# What's New in [ 2013 - 2016 - 2019 ]

## **Safety Code for Elevators and Escalators**

What's New in ASME A17.1-2013 to A17.1-2019 CSA B44-13 to CSA B44:19

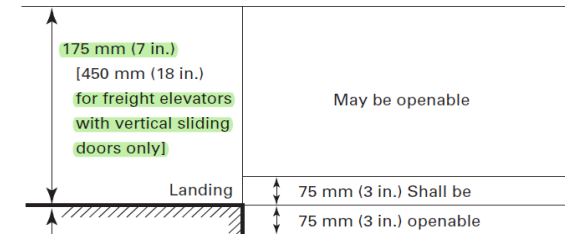
43	2.11.10.2	2019	<p><b>Illumination at Landing Sills</b> Revised</p> <p>Remove specific language related to "building corridor"</p>	<p>Rationale: To mitigate tripping and other hazards, the sills must be illuminated when the elevator is in service. The current edition does not address the situation where there is no building corridor.</p>	
42	2.11.11.1	2013	<p><b>Landing Sills</b> Subparagraph (d) added</p> <p>2.11.11.1 Landing Sills. Landing sills shall</p> <p>(d) be permitted to include the corresponding member of a bottom guiding means (see 2.11.11.5.7 and 2.11.11.6).</p>	<p>Rationale: <b>To clarify that a sill/sill structure is permitted as a guiding component. When a sill/sill structure is used as a guiding component then they must meet the strength requirement of 2.11.11.5.7</b></p>	[OEM] design permission

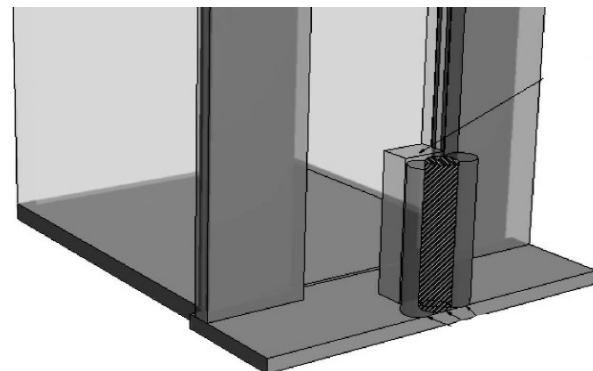
58	2.13.5	2019	<p><b>2.13.5.3 Detection of Approaching Objects.</b></p>	<p>3D requirement is to <b>detect a cylindrical target(s)</b> approaching the entrance opening of the landing-side doors as required by 2.13.5.3.1</p> <p><b>cylindrical target is 200 mm (8 in.) Dia., 1 000 mm (40in.) High. Flat black (absorb light) &amp; gloss white (reflect light)</b></p> <p>Moving point of detection is:</p> <ul style="list-style-type: none"> <li>- between 225 mm (9 in.) and 500 mm (20 in.) in front of the door and</li> <li>- 225 mm (9 in.) ahead of the leading edge [see appendix S-16]</li> </ul>	<p>[I]- refer to appendix S-16 for the area of detection.</p> <p>Note that the object detection is test requirement for the OEM to validate - it is not an expectation to validate this in the field by inspectors</p>

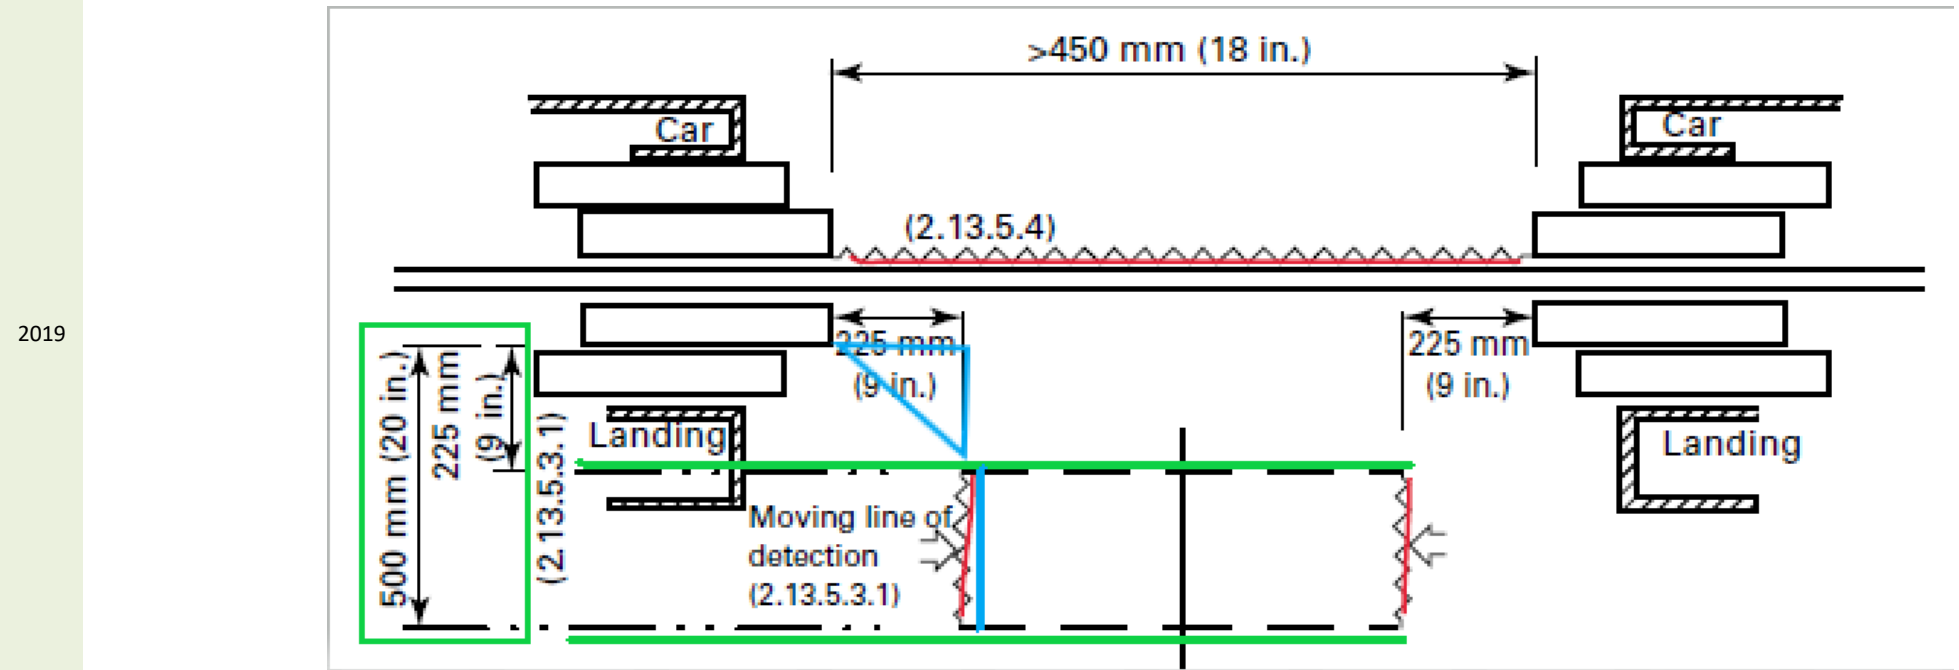
2019 **Green lines forms the two planes to define distance in front of doors where 3D detection should occur.**  
 Red line (2.13.5.4) is the 2D detector beam, Red line between the green planes is the moving line of object detection. The 3D detector must sense an object on the red line at some point on the red line - but not at all points on the red line.  
 The blue triangle establishes distance for how far in front of the doors, and how far in front of the leading edge the moving detection line must be.

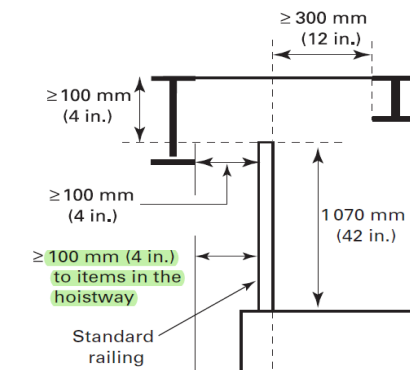
58, 59	2.14.1.7.2	2016	<p>Revised <del>When the car has reached its maximum upward movement (2.4.6.1), the following</del> minimum clearances shall be provided from the top rail <b>and intermediate rail</b> of the standard railing, <b>as specified in 2.10.2</b>, to the building structure or elevator equipment <b>in relative motion to the standard railing not attached to the car:</b> <b>(a) when the car has reached its maximum upward movement (2.4.6.1):</b> <b>(a) 100 mm (4 in.) vertically</b> <b>(2) 300 mm (12 in.) horizontally towards the centerline of the car enclosure top</b> <b>(b) throughout the hoistway, (b) 100 mm (4 in.) horizontally in the direction towards the hoistway enclosure,.</b> <del>(c) 300 mm (12 in.) horizontally towards the centerline of the car enclosure top.</del> NOTE: (2.14.1.7.2): See Nonmandatory Appendix G.</p>	<p><b>Top and Mid rail handrail running clearances shall be 100mm (4 in.) throughout the hoistway</b></p> <p>Rationale: Revised to ensure protection of elevator personnel against shearing hazards throughout the hoistway between the top rail and intermediate rail of the standard railing and fixed equipment passed or approached by the standard railing as the car moves throughout the hoistway</p>	<p>[I]- Running clearance dimension field verifiable at inspection</p> <p>Note, only top and intermediate rails are referenced.</p> <p>Posts and toe boards not referenced.</p>
